Lakes & Waterways Advisory Board

August 14, 2018 12:00 noon

Shoreline Alteration Permit Application Staff Report (Seawall)

Application #: 18-12 WATERBODY: Lake Sue

SHEET NO. C-1

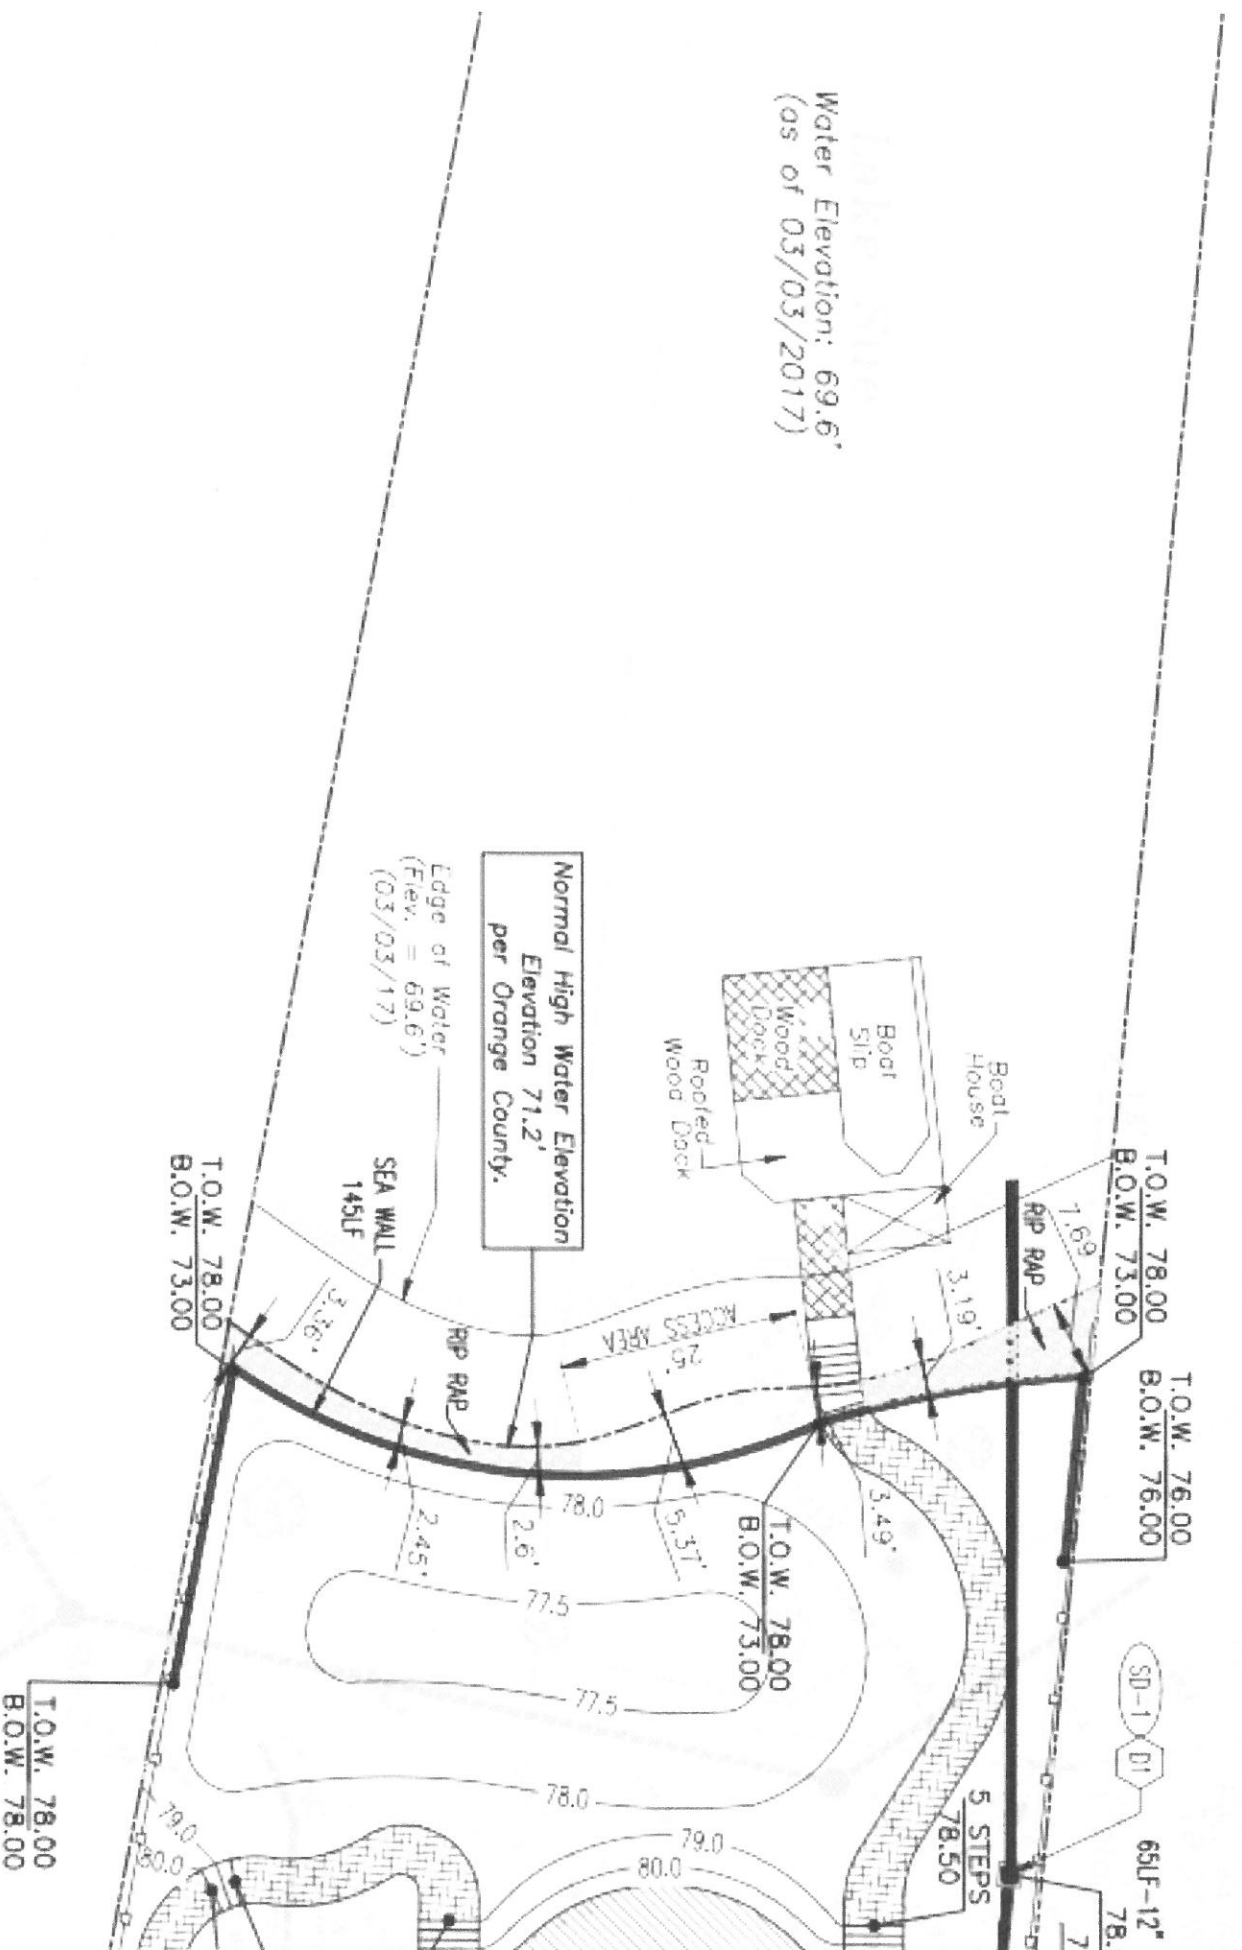
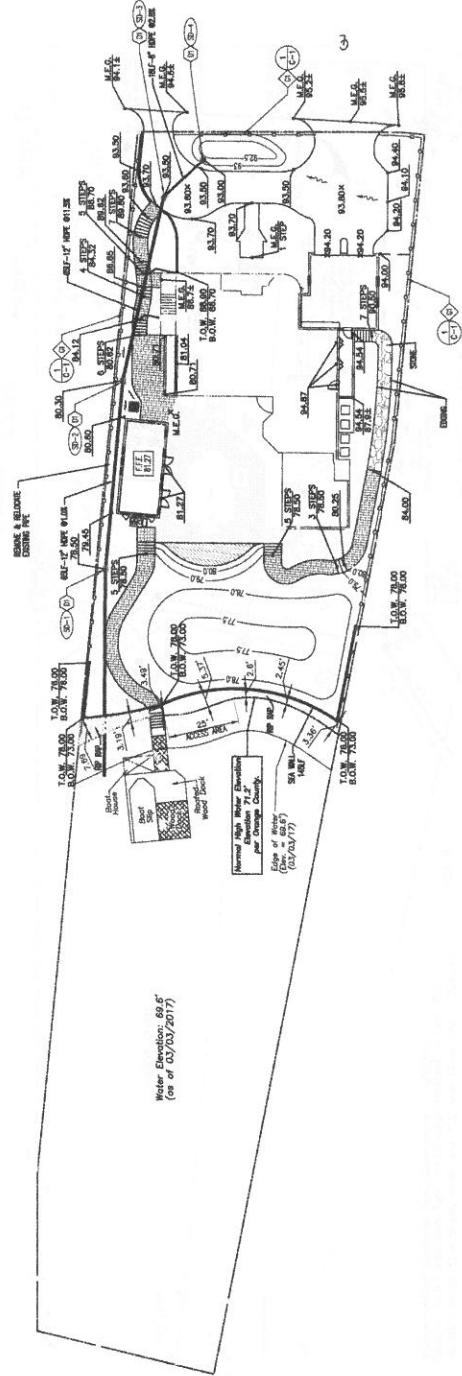
- The applicant is proposing to install a vertical vinyl sheetpile wall 145' in length capped with concrete to replace a failing vertical wooden seawall that doesn't meet code. A 3:1 sloped revetment is required to protect the shoreline from erosion problem and to stop reverberation, but this is not included in the application sketches. The site does not currently meet the vegetation requirements and will need to be replanted by October 14, 2018 for compliance.

- Denial.
- Requested updated sketches to include 3:1 revetment and geotextile fabric installation.
- Requested shoreline vegetation application to be completed as part of permit package.

Existing
Wall to Be
Replaced

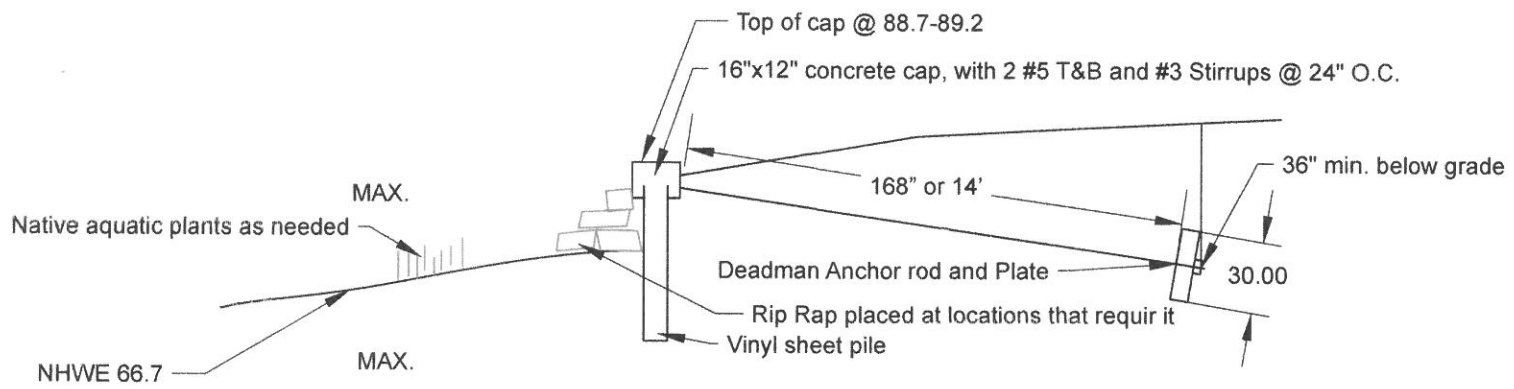
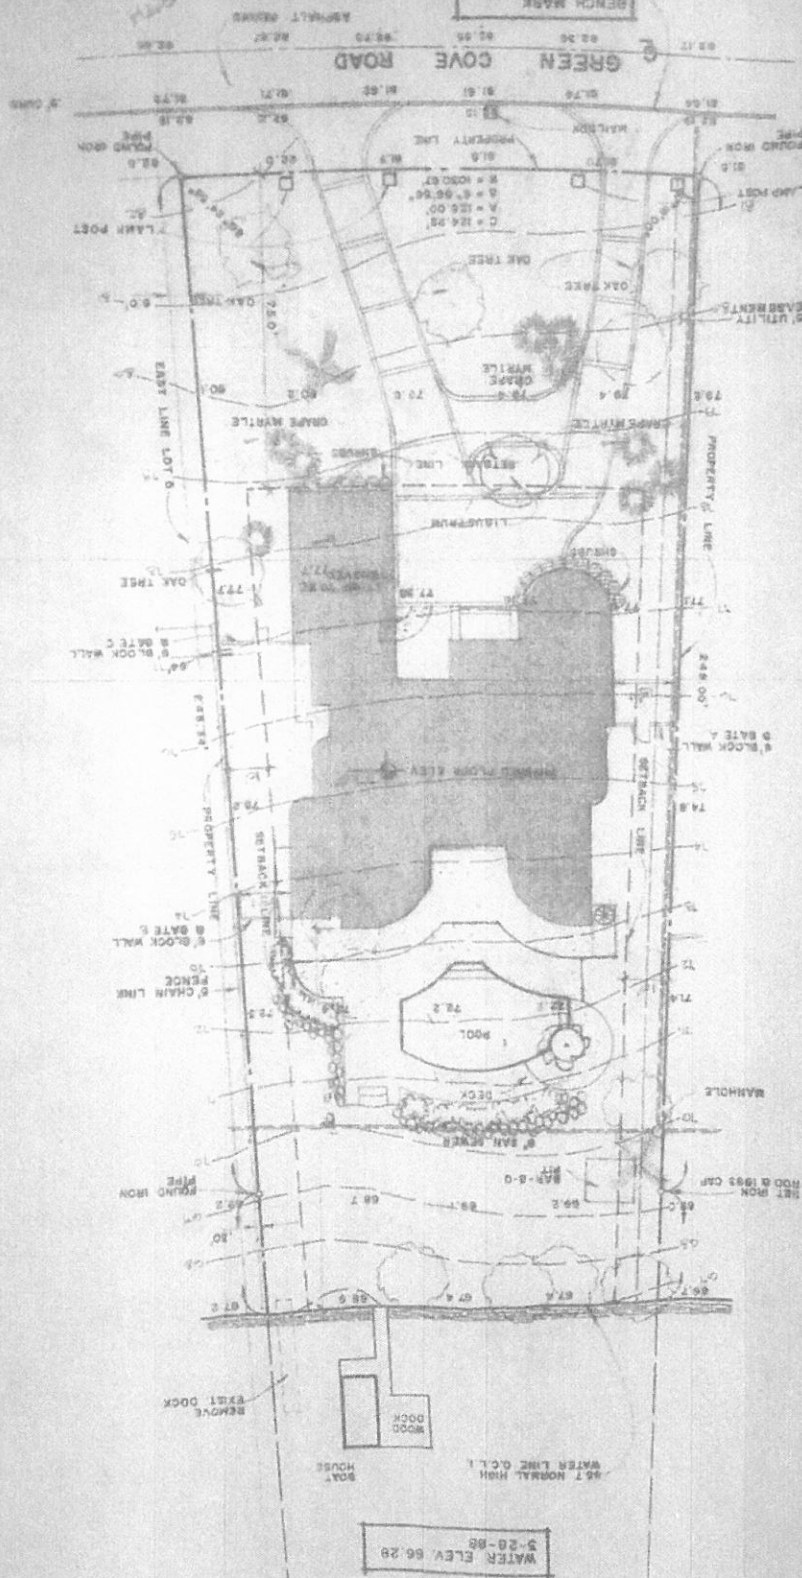
- The applicant is proposing to install a vertical vinyl sheetpile wall in two segments (23' and 26' in length, respectively, capped with concrete) to replace a failing vertical wooden seawall that doesn't meet code. A 3:1 sloped revetment is required to protect the shoreline from erosion problem and to stop reverberation, but this is not included in the application sketches. The site does not currently meet the vegetation requirements and will need to be replanted by October 14, 2018 for compliance.

- Denial.
- Requested updated sketches to include 3:1 revetment and geotextile fabric installation.
- Requested shoreline vegetation application to be completed as part of permit package.

Profile View
Natural Stone Revetment

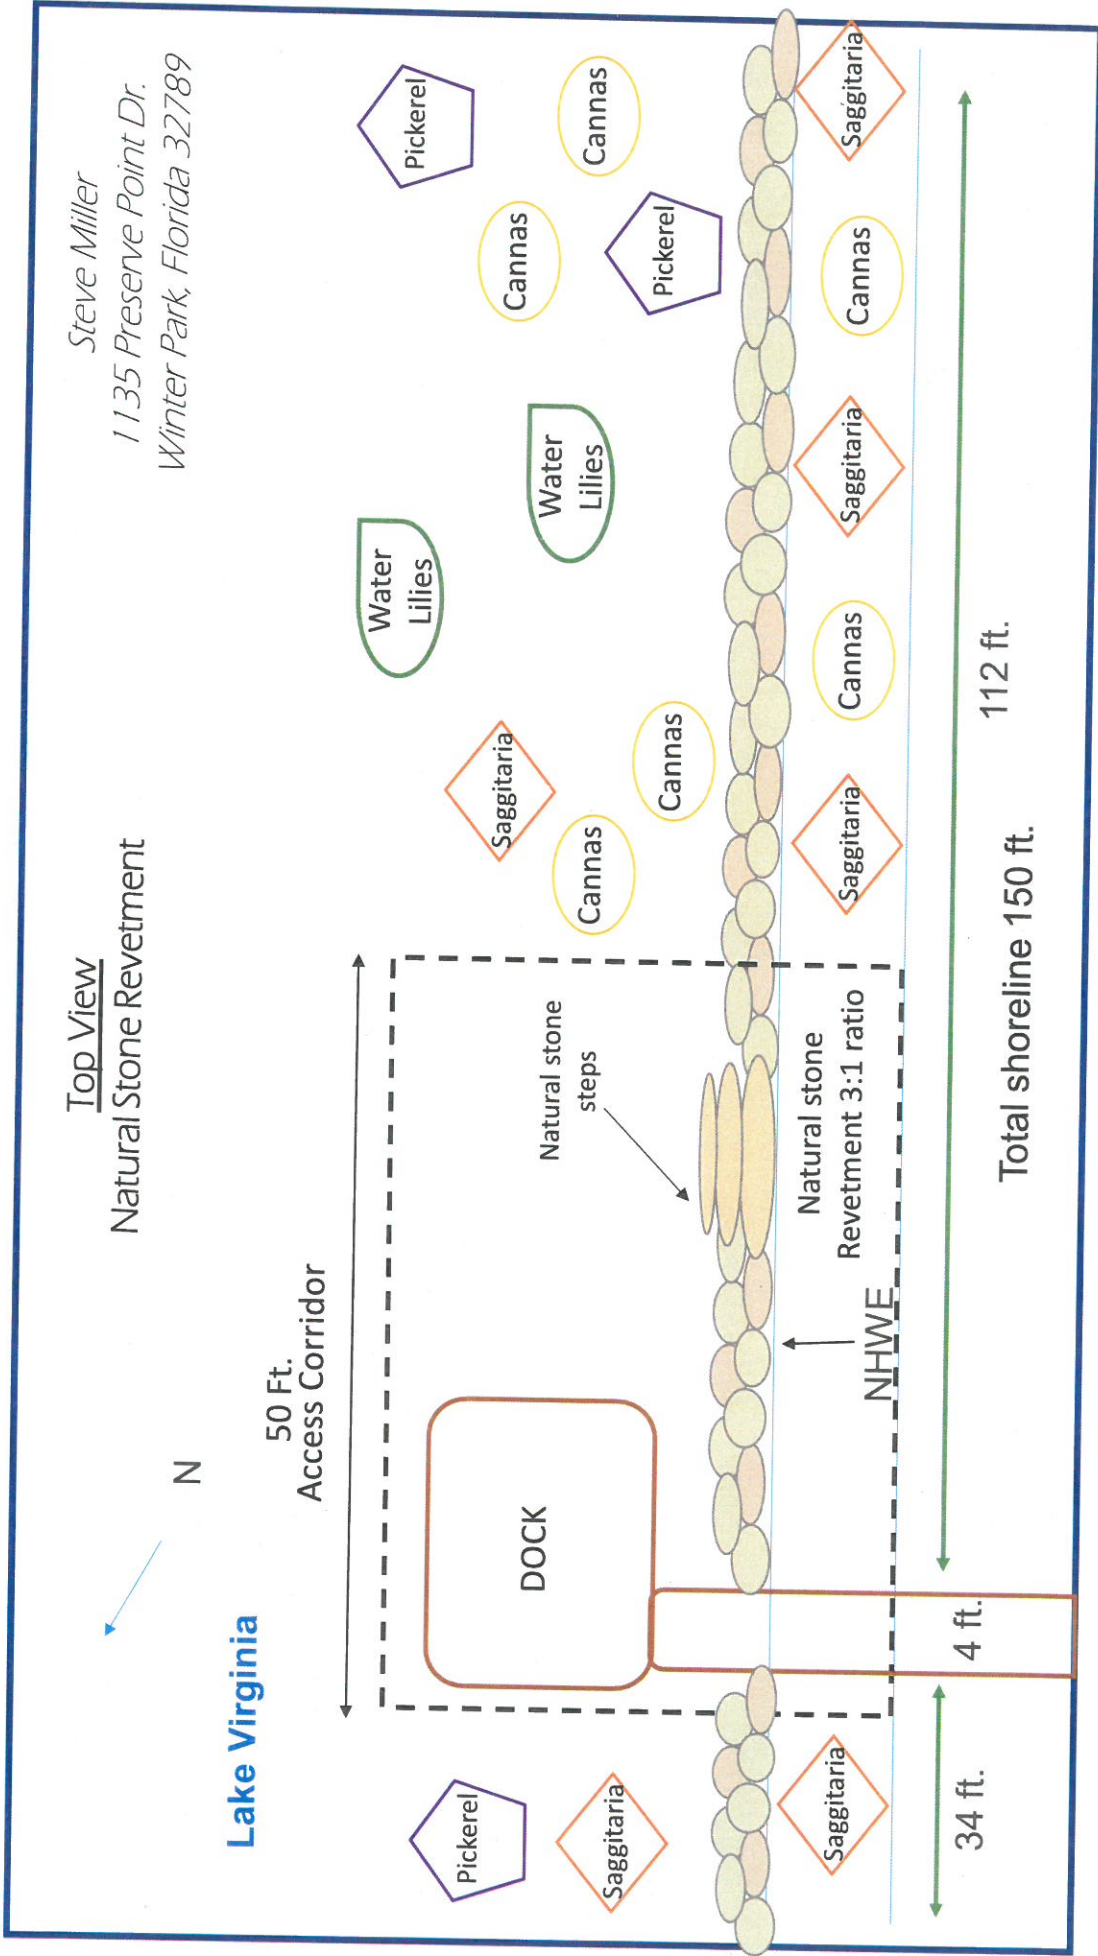
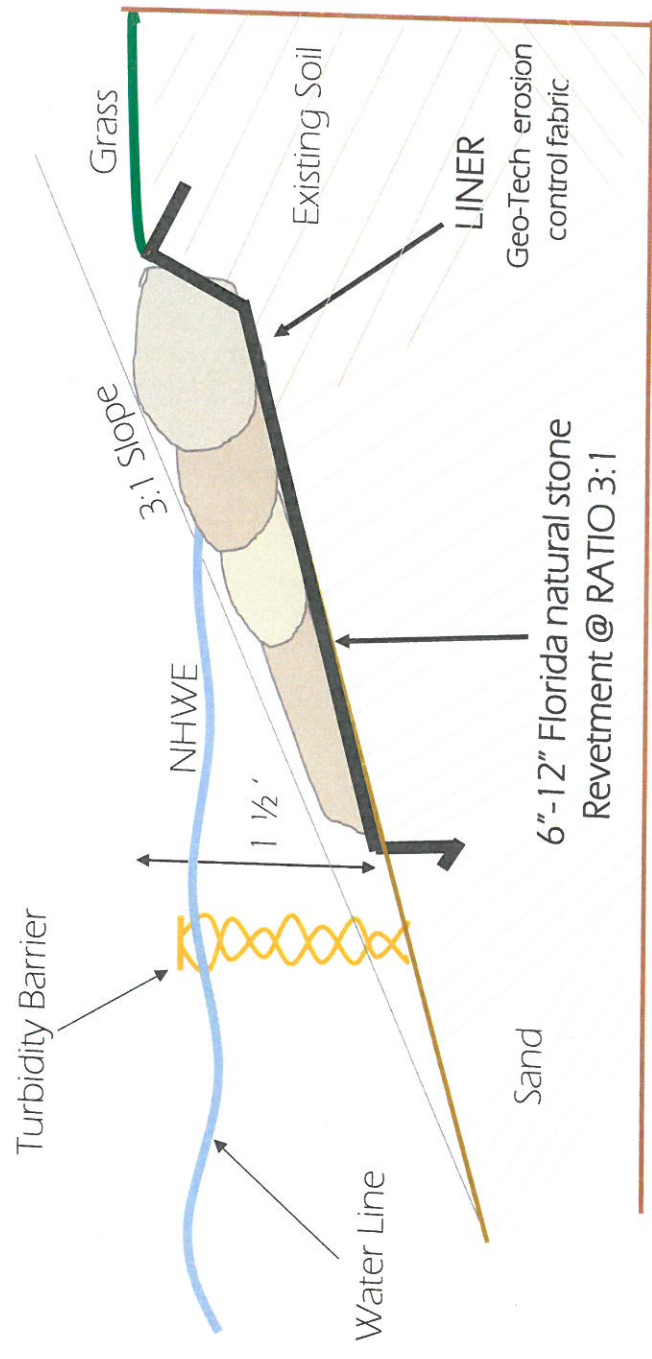
- The applicant is proposing to create a revetment (150' in length) using 6-12" Florida natural limestone atop stabilizing geotextile fabric installed at a 3:1 slope to protect the shoreline from an ongoing erosion problem and to stop reverberation from waves. The site does currently meet the vegetation requirements, but the applicant will be removing exotics and replanting areas to enhance native aquatic plant stands.

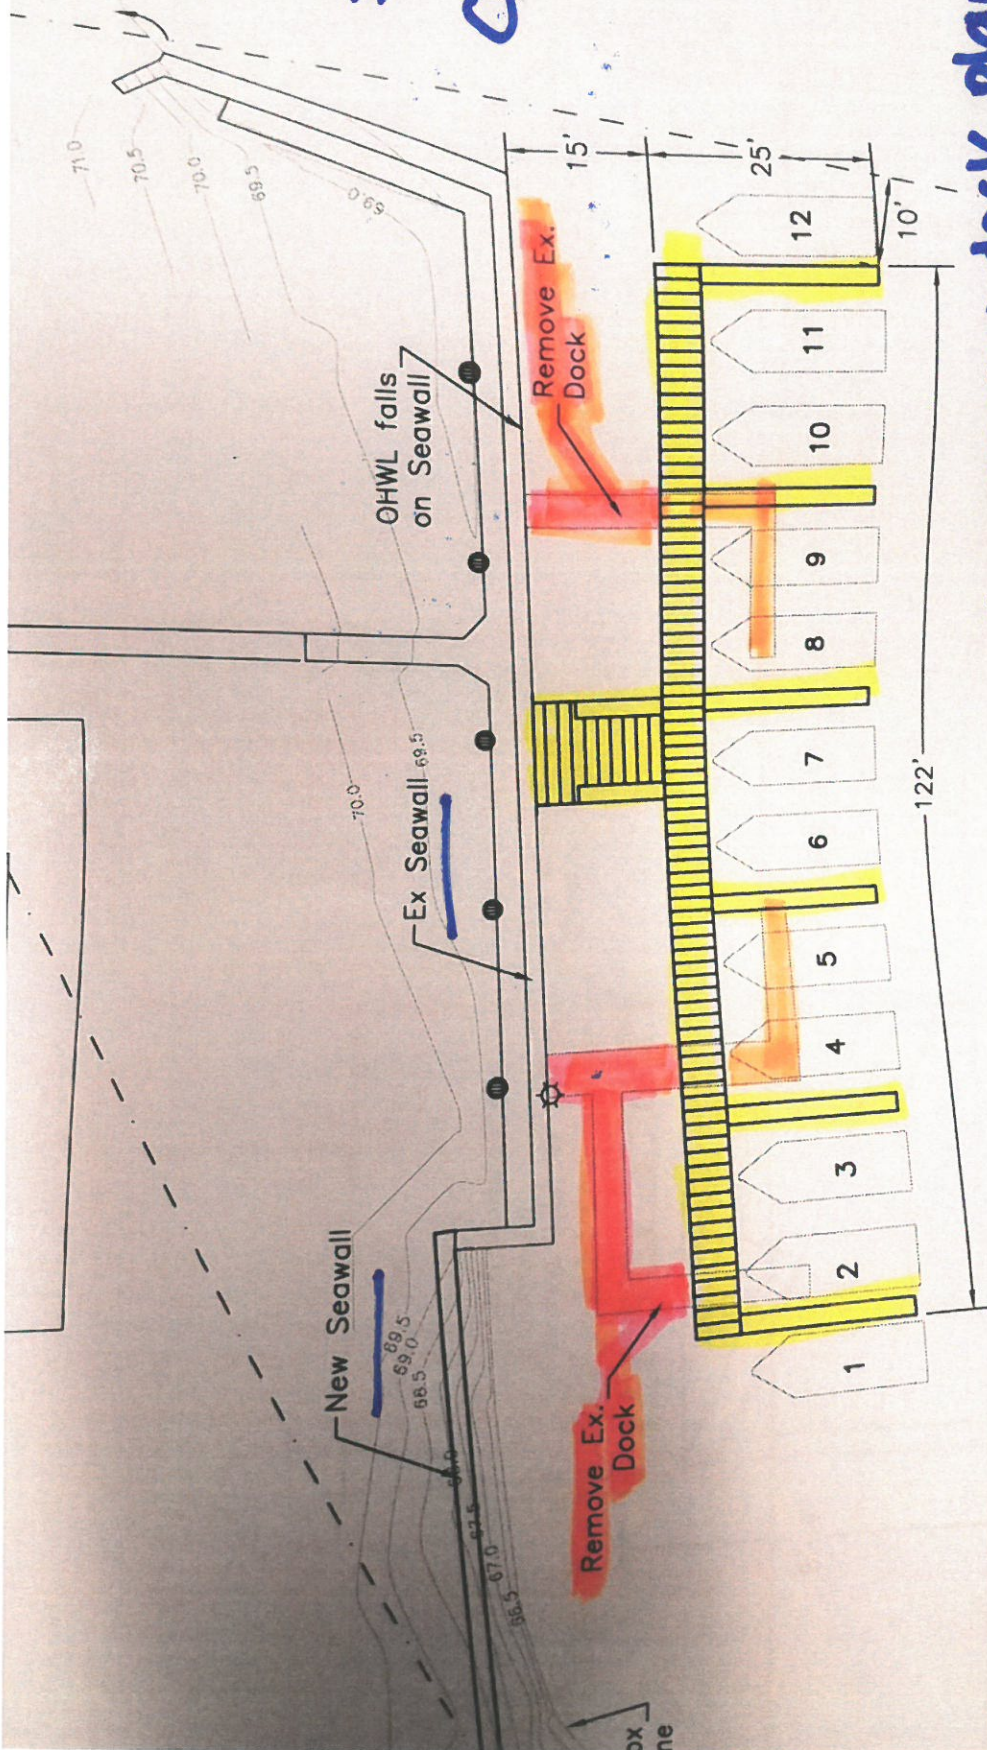
- The applicant is proposing to install a vertical sheetpile wall 70' in length to be added to the existing 120' in place. Vertical walls do not meet the current code, and a 3:1 sloped revetment is required to protect the shoreline from erosion problem and to stop reverberation. The site does not currently meet the vegetation requirements and will need to be replanted by October 14, 2018 for compliance.

- * yellow - new dock plans.
- * orange - dock to be removed.
- = 70' of new seawall - but 57' attached to existing wall plus 13' to wrap around the side.

- Denial.
- Applicant's contractor says wall will be entirely above NHWE; plans submitted do not reflect that, so awaiting final confirmation.
